DRAINAGE CONDITION DISCHARGE

Document Reference. 1-21554-CCL-DA-001

Planning Application No	136933/FO/2023
Site Location	DIXONS ACADEMY
Description	NEW 2 STOREY CLASSROOM EXTENSION BLOCK AND NEW SPORTS HALL ON EXISTING SCHOOL SITE
Applicant Name	DEPARTMENT FOR EDUCATION

LLFA Drainage comments.

Client	MORGAN SINDALL CONSTRUCTION
Project	DIXON NEWALL GREEN ACADEMY
Office	ALTRINCHAM
Discipline	CIVILS
Title	DRAINAGE DETAILS SHEET 3
Scale @ A1	NTS
Status	STAGE 4

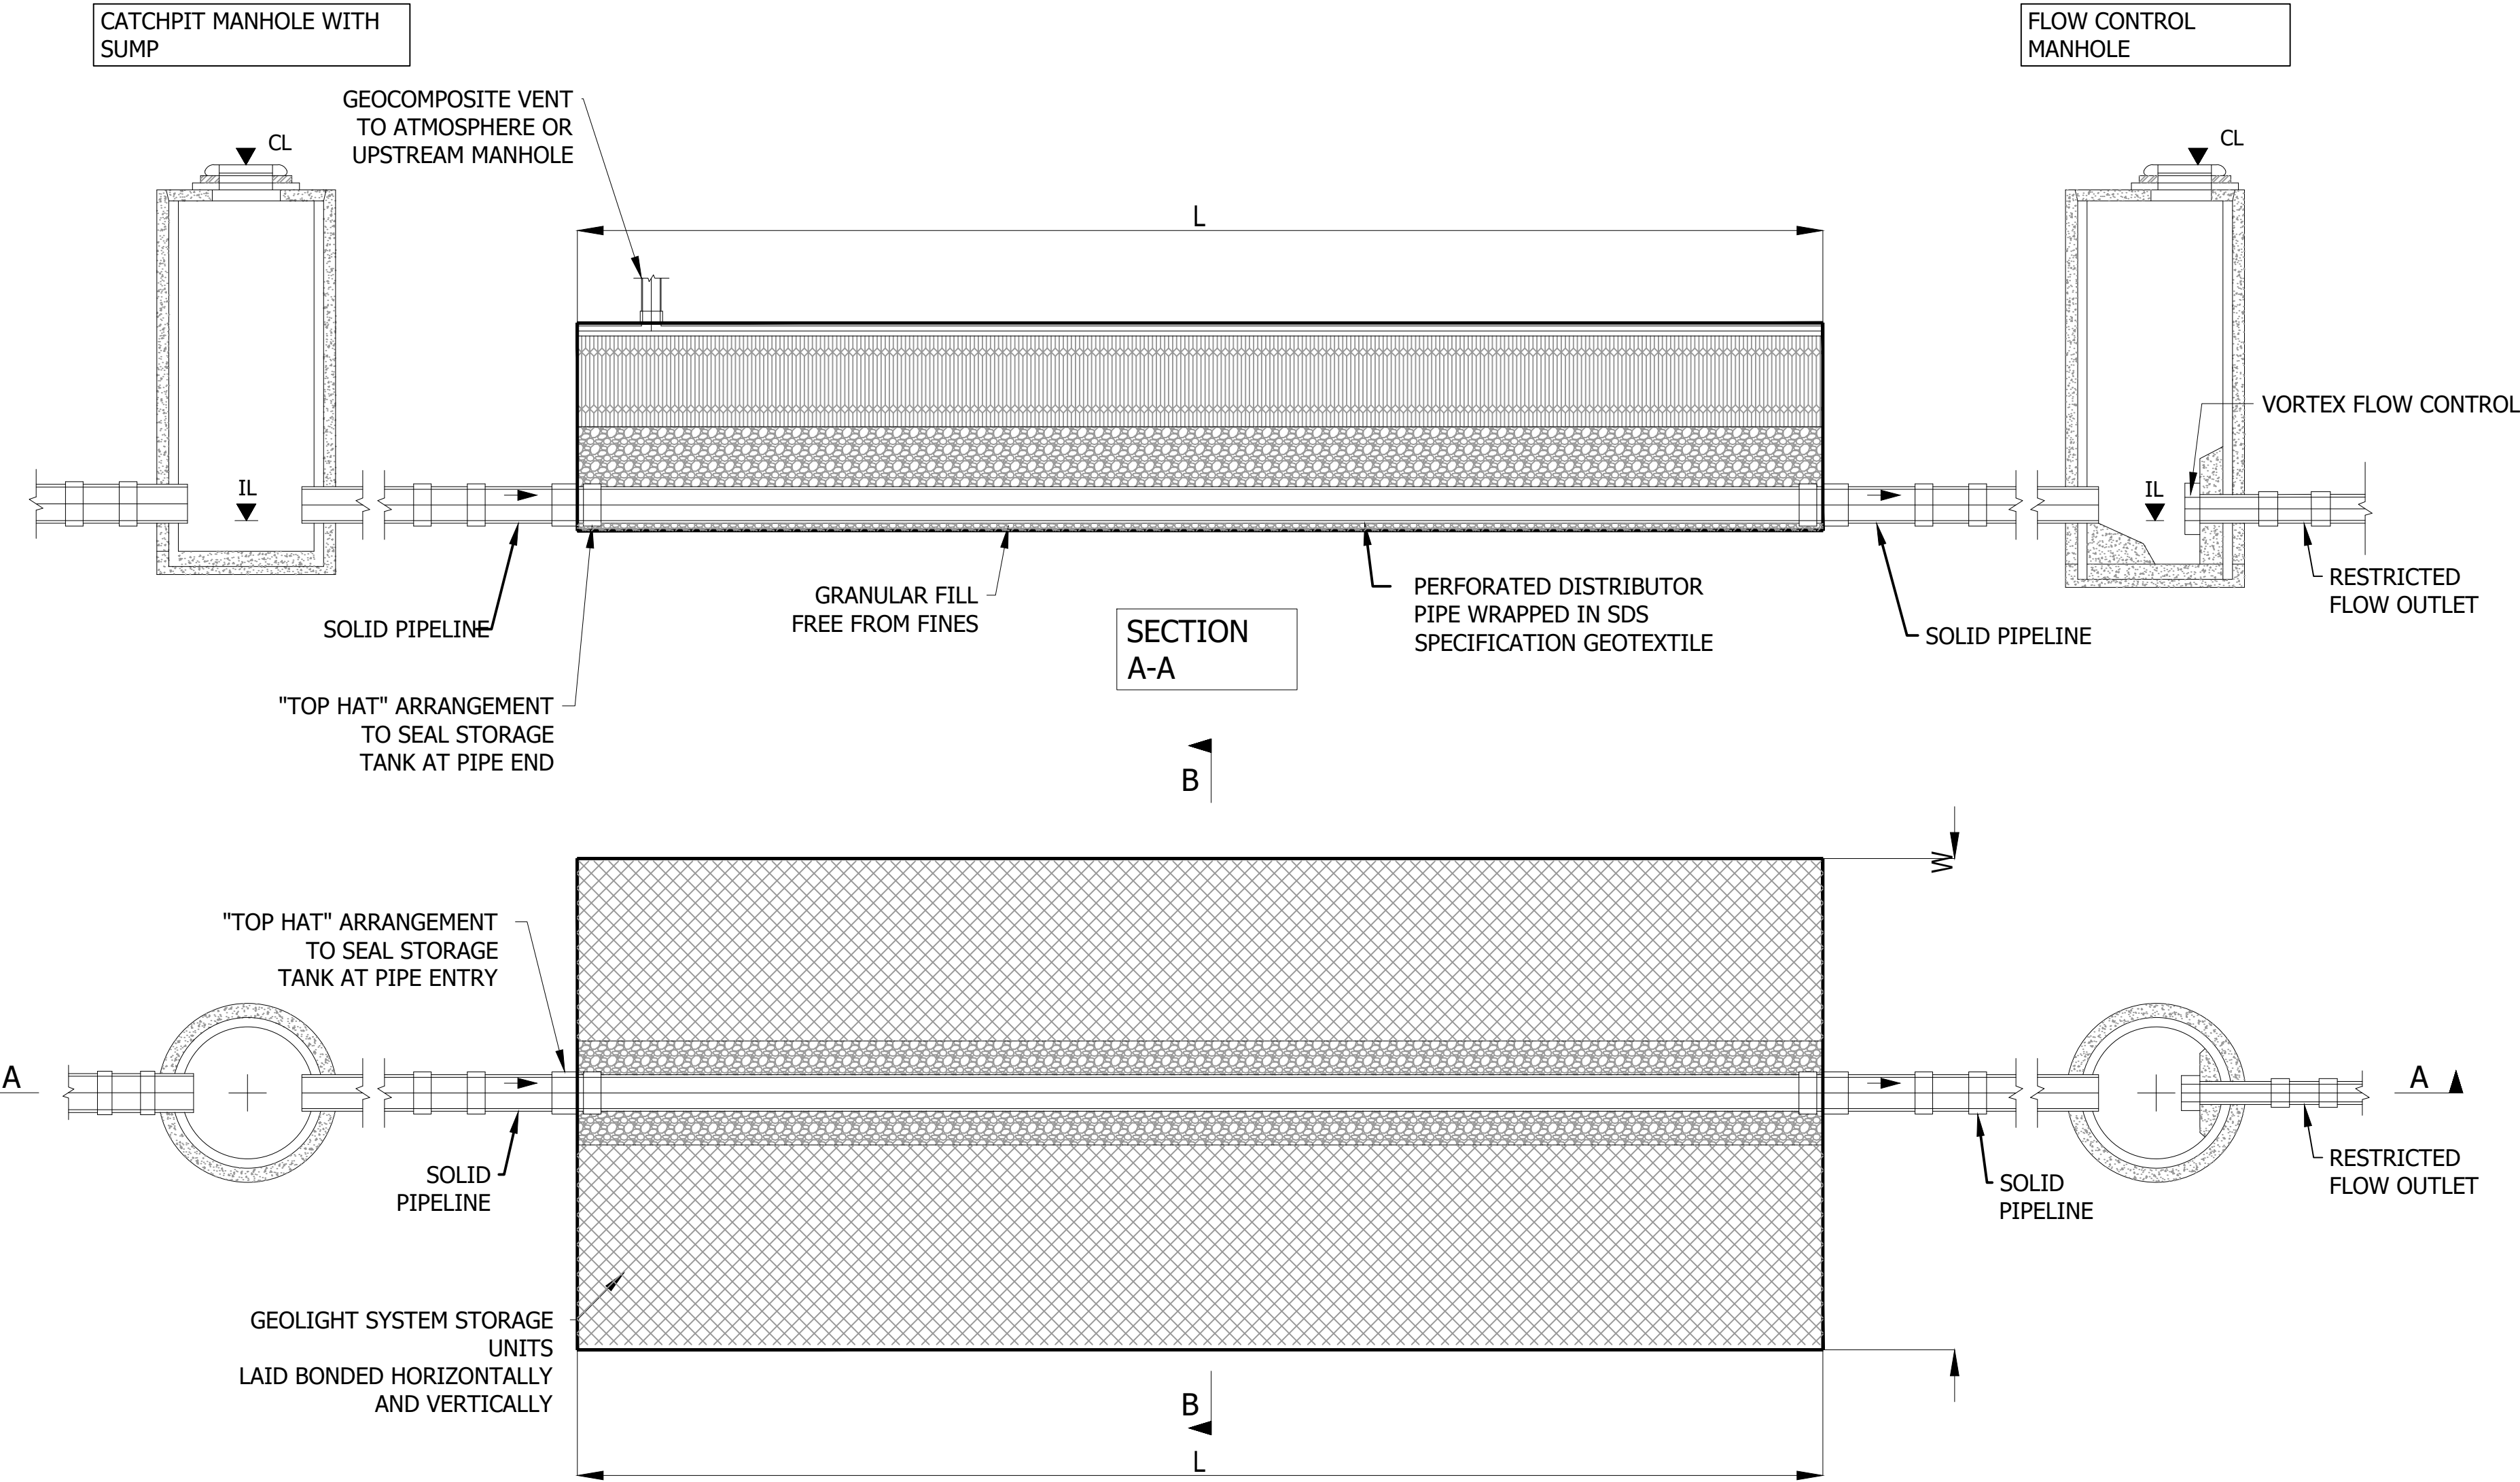
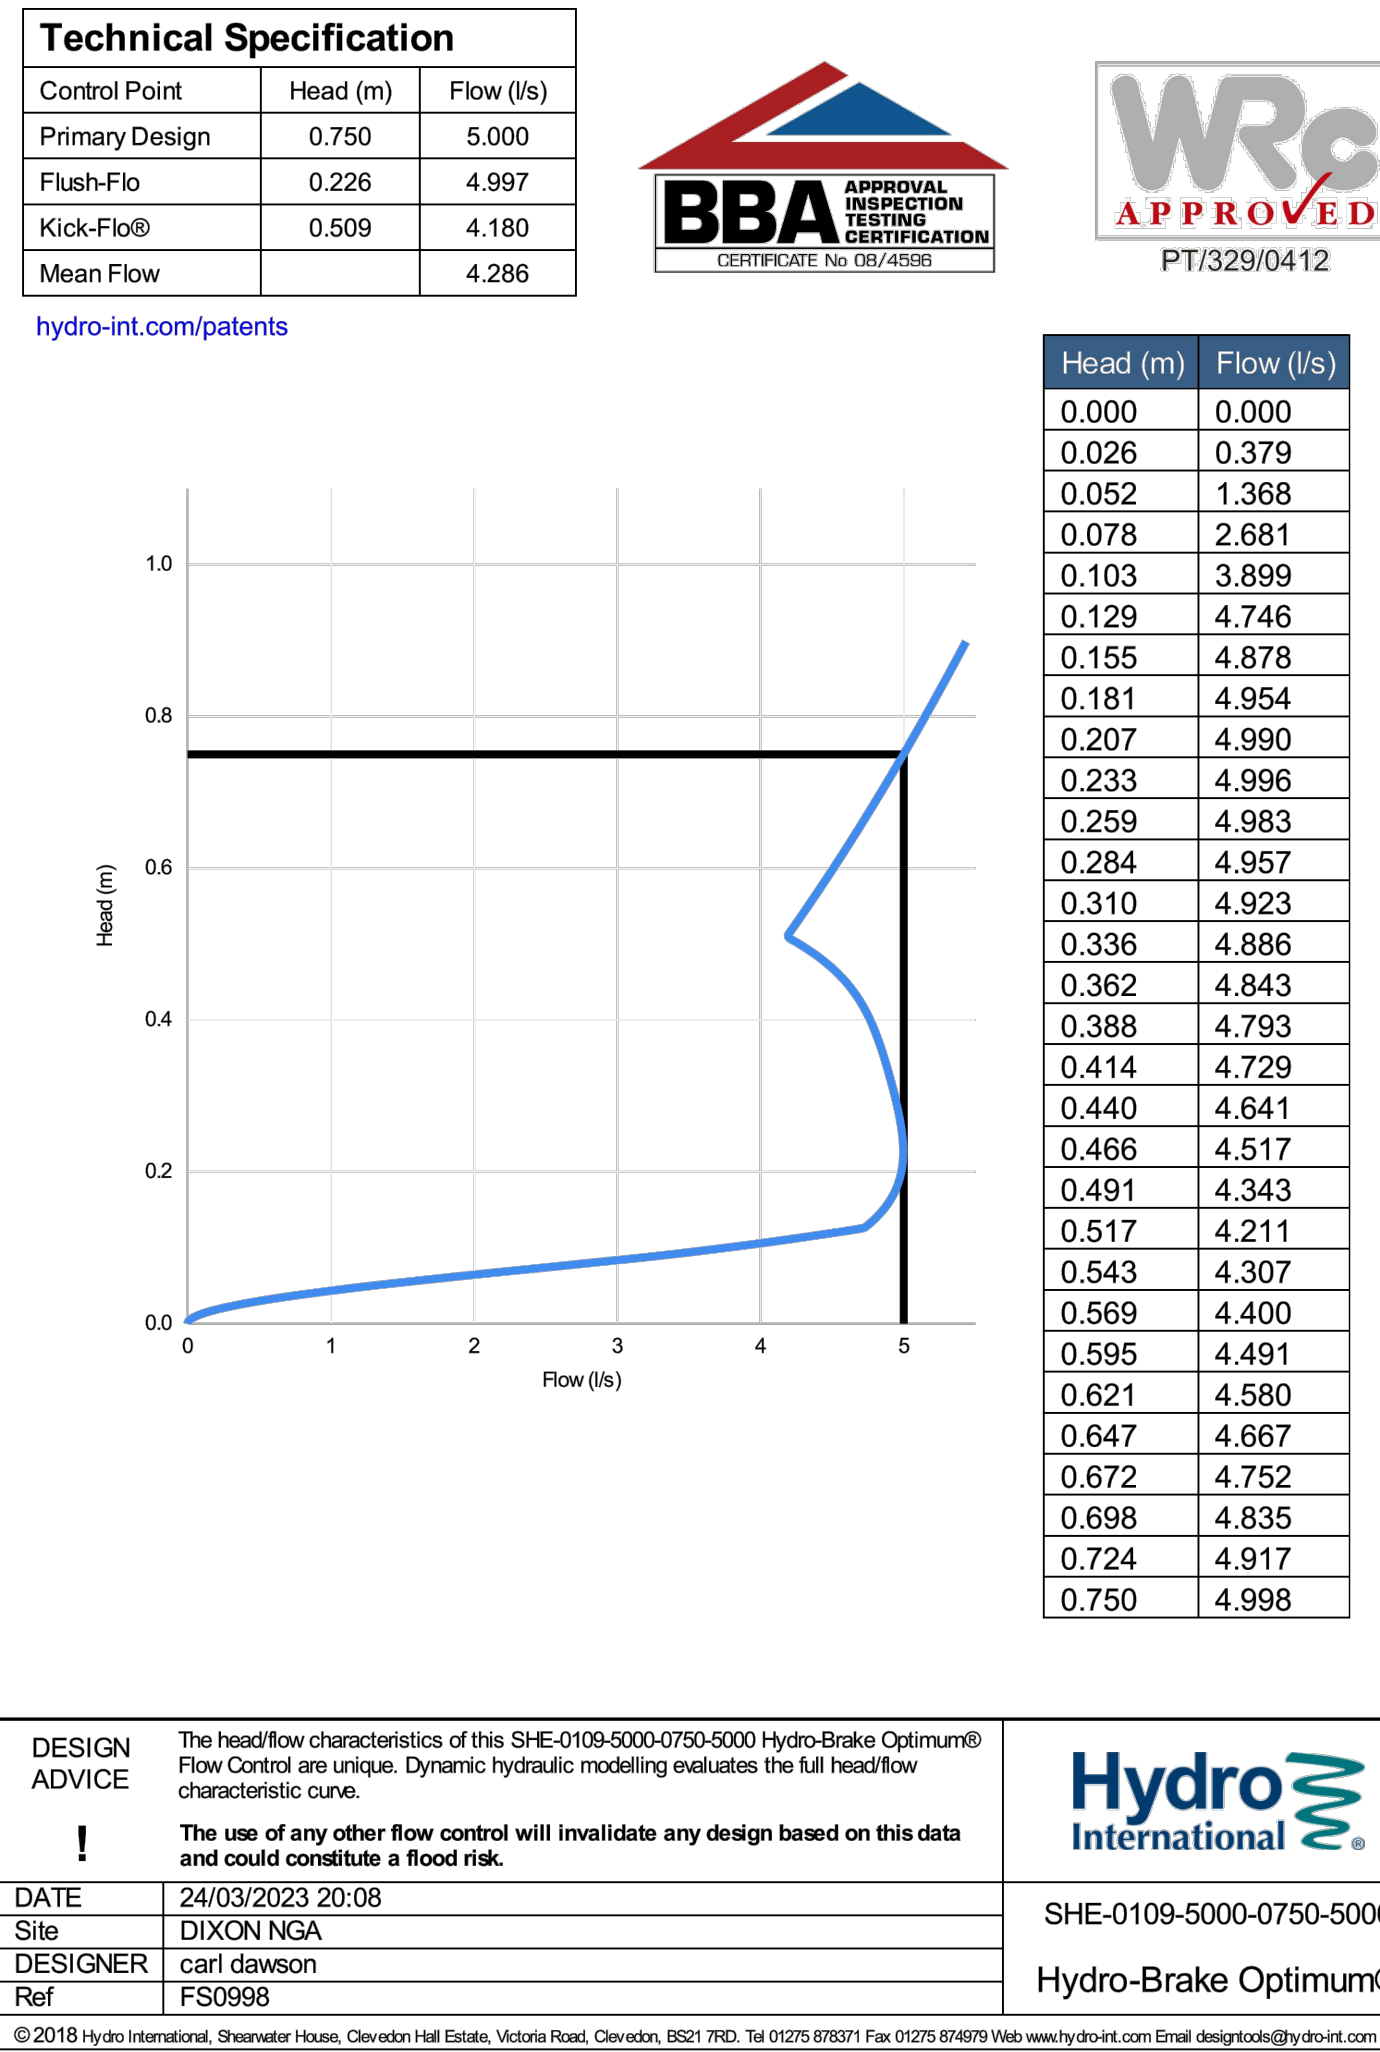
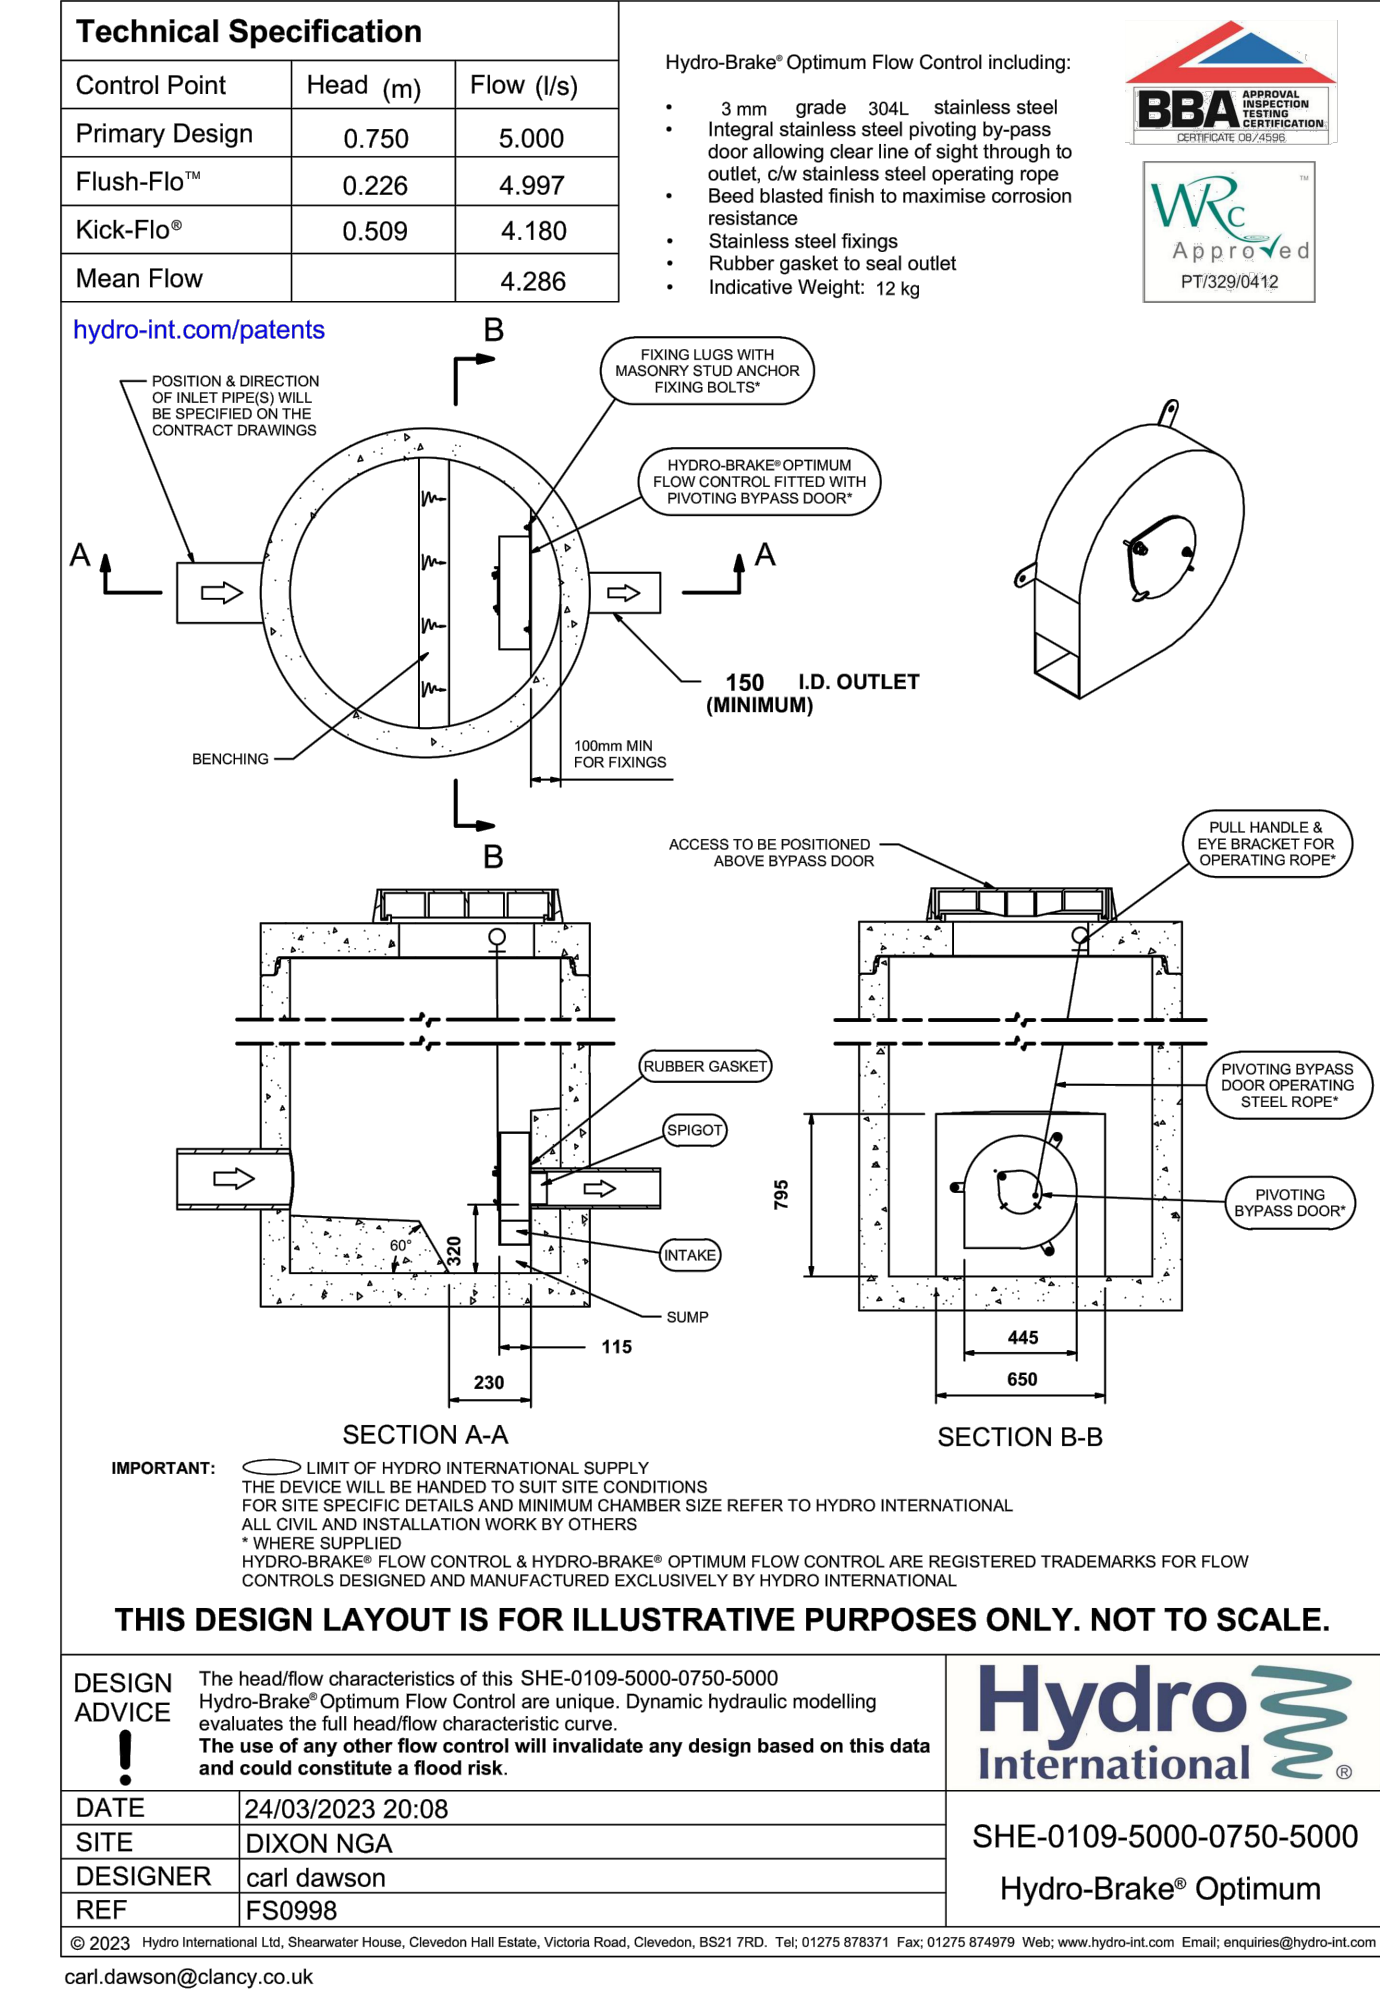
- Construction details of flow control and SuDS elements.

Refer to details appended to the back of this document.

IL = c.53.55m AOD
TANK HEIGHT = 0.75m
REQUIRED VOLUME = c.200m³
